# RCAN-01 User's Manual Rev A – Errata

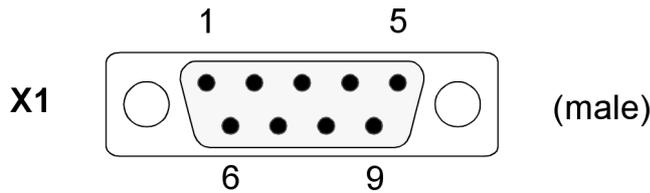
Replace the diagram of the connector X1 with the following (note the order of pin numbers):

Standard 5 pin miniature connector

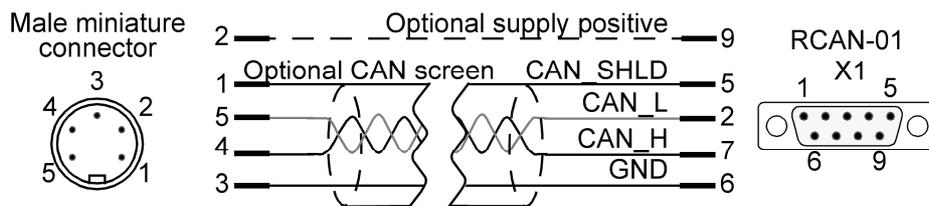
Replace the wiring diagrams with the following (note the order of pin numbers):
